# SPECIAL SEISMIC CERTIFICATION REQUIRED SEISMIC ENHANCEMENTS

**Document Number** 2019-030-CCS-01-02  
**Manufacturer** Bender Incorporated  
**Model Line** MIP, MIX, MIE, MIC, MID

## Transformer Shelf Reinforcement Detail

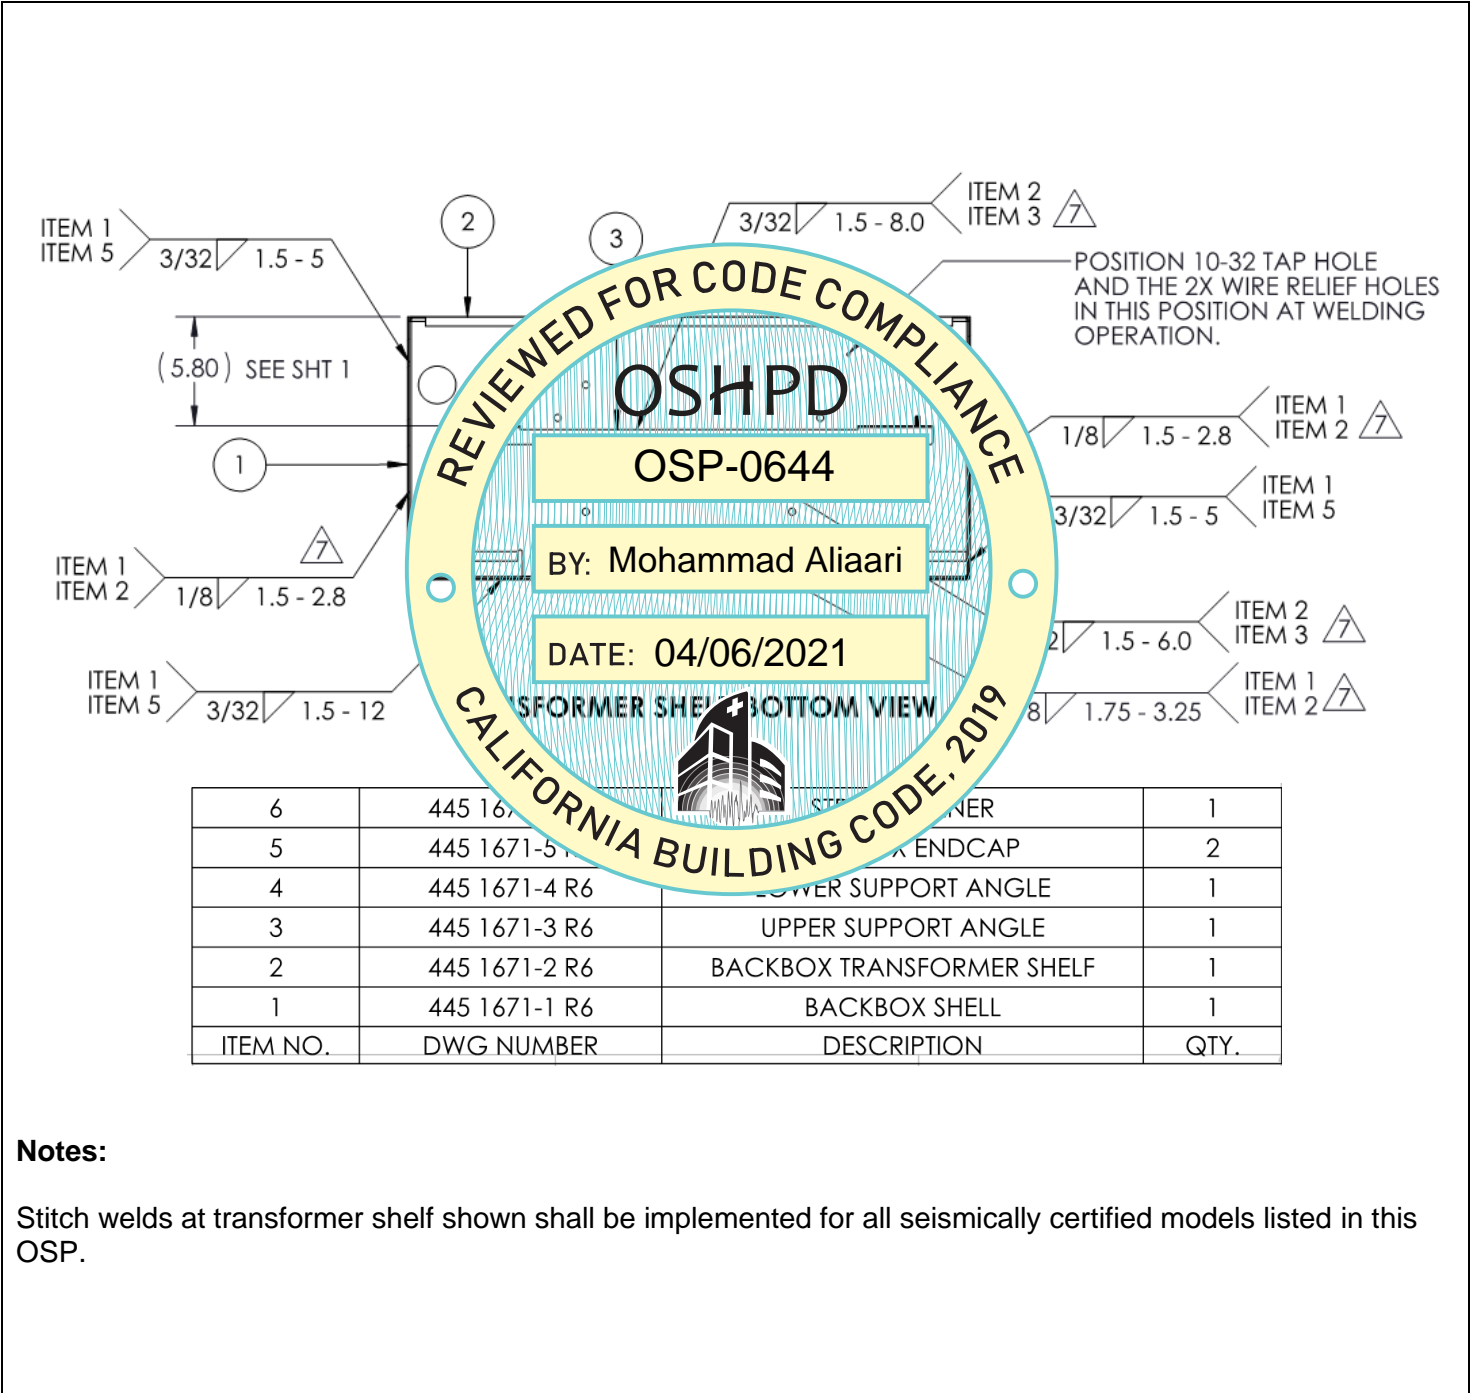
Stitch welds at transformer shelf shown shall be implemented for all seismically certified models listed in this OSP.
